Your reference: MCUI/2023/192  
Our reference: P6218.001L\_Further IR Letter

**RE: FURTHER INFORMATION REQUEST LETTER RESPONSE**  
**689 TOOWOOMBA CECIL PLAINS ROAD, WELLCAMP**

Specifically this letter responds to Transport Item 2.

**Figure 2.1: Toowoomba Cecil Plains Road / Deuble Road & Heinemann Road SIDRA Intersection Layout – Single Lane Roundabout**

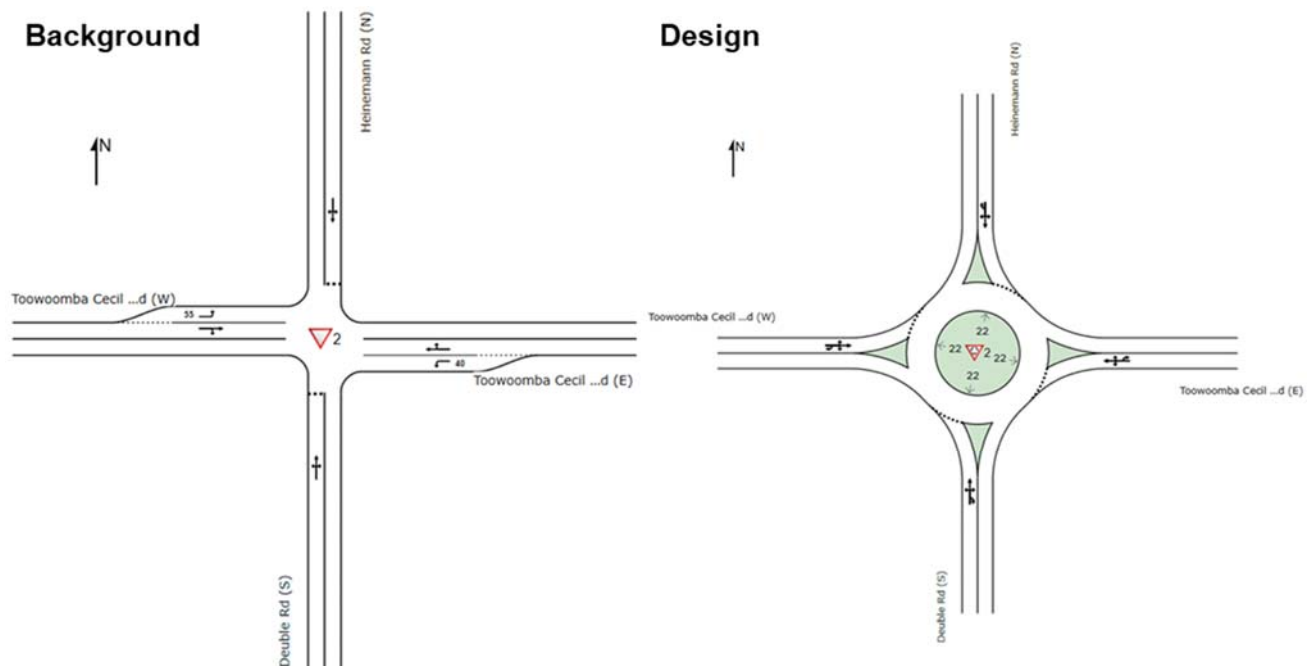
- The TIA has not adequately assessed the road safety impacts associated with the development. The TIA proposes that the four-way priority control intersection at Toowoomba Cecil Plains Road/Deuble Road/Heinemann Road is retained, however this is the least safe form of intersection treatment. An offset tee arrangement or a single lane roundabout would mitigate some of the road safety impacts of the subject site.*

To ensure there are no potential operational issues of an alternative configuration for the Toowoomba Cecil Plains Road / Deuble Road & Heinemann Road intersection, a roundabout layout has been assessed using the same background and design traffic volumes detailed in the TIA report (*ref: P6218.001R 689 Toowoomba Cecil Plains Road TIA*) undertaken by Bitzios Consulting as detailed in Section 2.2. Traffic volume diagrams have been provided at **Attachment B**.

The Toowoomba Cecil Plains Road / Deuble Road & Heinemann Road roundabout intersection layout as assessed in SIDRA for the 2040 background and design years is shown in Figure 2.1.

As shown, the Toowoomba Cecil Plains Road / Deuble Road & Heinemann Road intersection is expected to operate within acceptable performance limits (in terms of DOS, delay, and queues) for a roundabout intersection in year 2040 with or without the future development. Furthermore, the introduction of future development trips is expected to have a negligible impact on intersection performance.

**Figure 2.2: Drayton Wellcamp Road / Devine Road SIDRA Intersection Layout - Realignment**

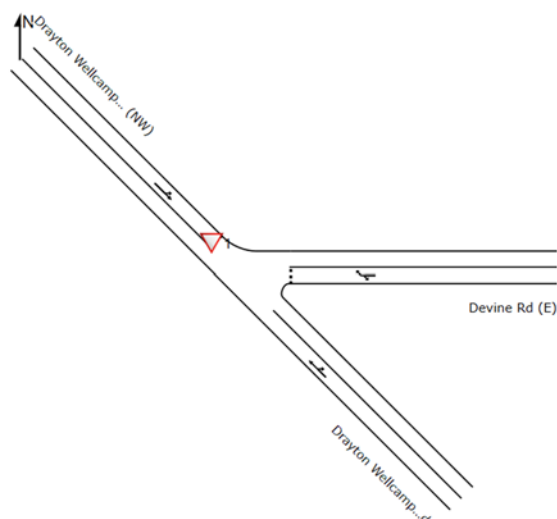
2. *Deuble Road is an existing trunk road as identified in the LGIP. The West Toowoomba Land Use Investigations December 2016 identifies Drayton Wellcamp Road and Deuble Road as the urban edge with a boulevard treatment to provide a buffer between residential uses and agricultural activities. The Structure Plan shows Drayton Wellcamp Road realigned with Deuble Road as the through road to reinforce the urban edge treatment. Devine Road was not intended to intersect with Drayton Wellcamp Road due to the current location on the outside of a curve on a higher speed road and the complications that future realignment of Drayton Wellcamp Road could create. 'Alford Grove' is conditioned such that no access is permitted to Drayton Wellcamp Road along Devine Road (RAL/2015/1869/A).*

The amended Structure Plan provided at **Attachment A** has been updated to show the realignment of Drayton Wellcamp Road as per the Glenvale West Structure Plan. The SIDRA layout for the Drayton Wellcamp Road / Devine Road intersection has therefore been amended to reflect the future realignment as shown in Figure 2.2. Traffic volume diagrams have been provided at **Attachment B**.

As shown, the realigned Drayton Wellcamp Road / Devine Road is expected to operate within acceptable performance limits (in terms of DOS, delay and queues) for a priority-controlled intersection at the expected 10-year design horizon (year 2050) with or without the future development.

**Figure 2.3: Hursley Road / North/South Distributor Road SIDRA Intersection Layout - Roundabout**

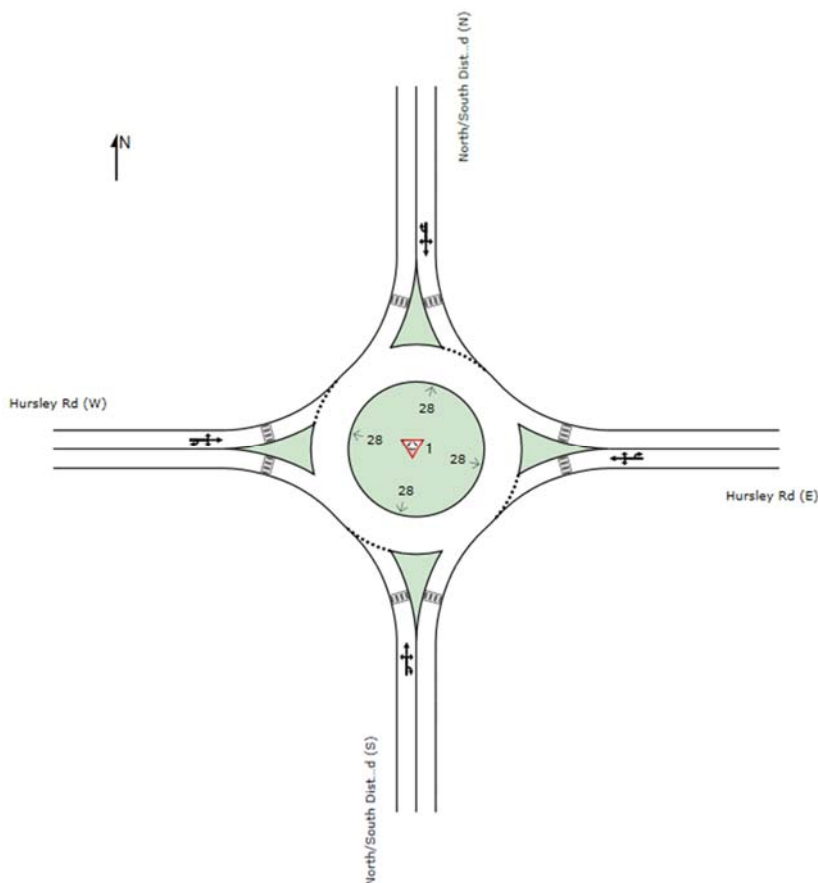
3. *The TIA has not considered traffic generated by the currently undeveloped land north of Gainsborough Lodge. This land is within the Priority Infrastructure Area (PIA) and development in this area could occur before development within the subject site. Access to Hursley Road for this site is expected to be in the form of a single lane roundabout aligned with the proposed Gainsborough Lodge intersection with Hursley Road. The TIA should be amended to reflect the development of this site with the primary access point being a single lane roundabout at Hursley Road.*

The Hursley Road / North/South Distributor Road has been reassessed adopting a roundabout configuration as shown in Figure 2.3, including the expected trips generated by the Northern PIA Development. Traffic volume diagrams have been provided at **Attachment B**.

As shown, the Hursley Road / North/South Distributor Road roundabout intersection is expected to operate within acceptable performance limits (in terms of DOS, delay and queues) at the expected 10-year design horizon (year 2050) with or without the future development and Northern PIA Development.

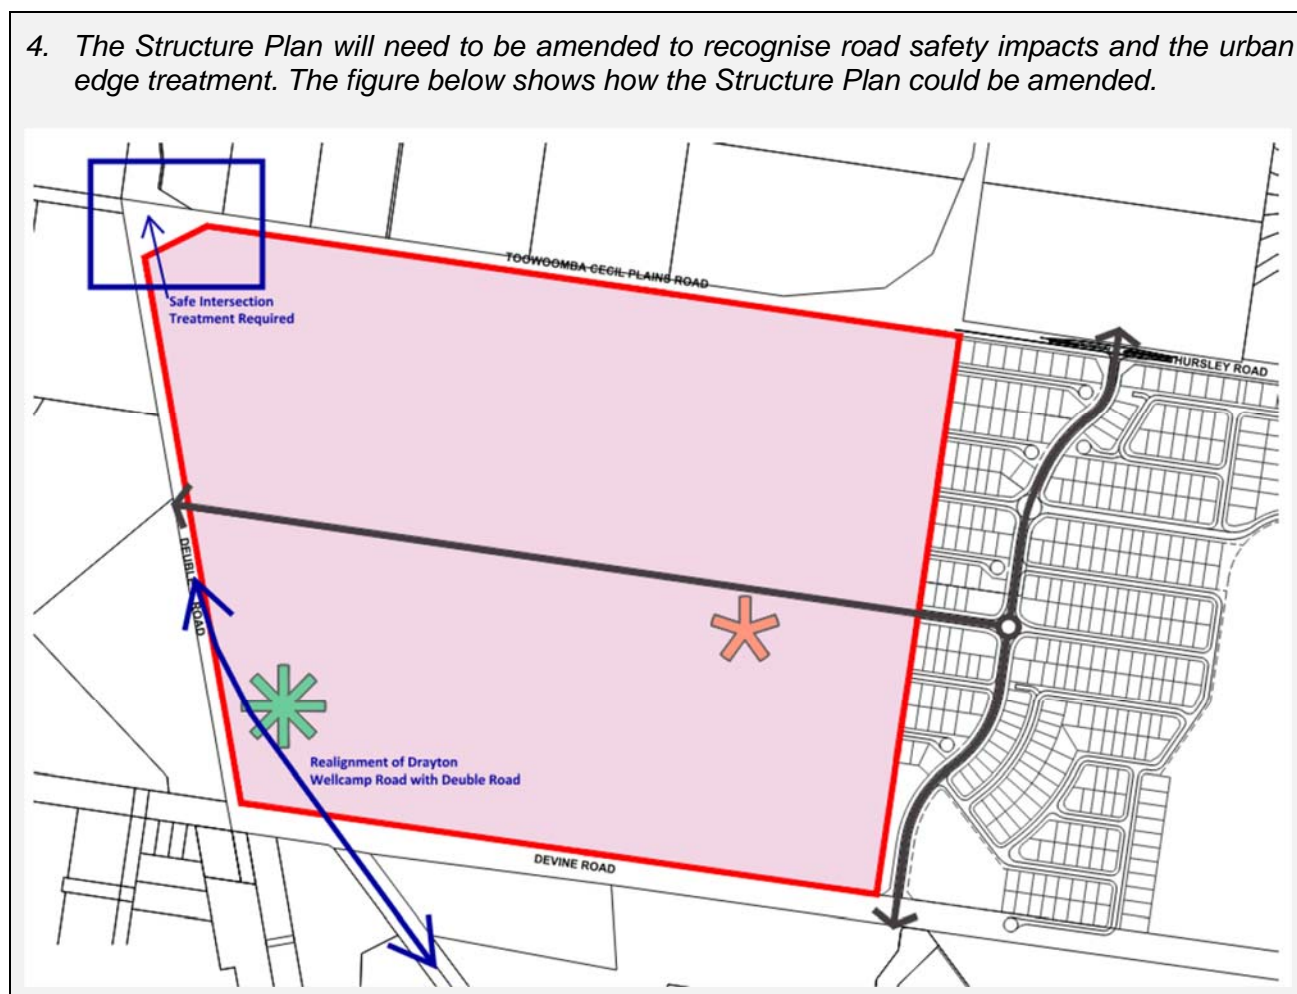
4. The Structure Plan will need to be amended to recognise road safety impacts and the urban edge treatment. The figure below shows how the Structure Plan could be amended.

An amended Structure Plan has been provided at **Attachment A** consistent with the above figure.
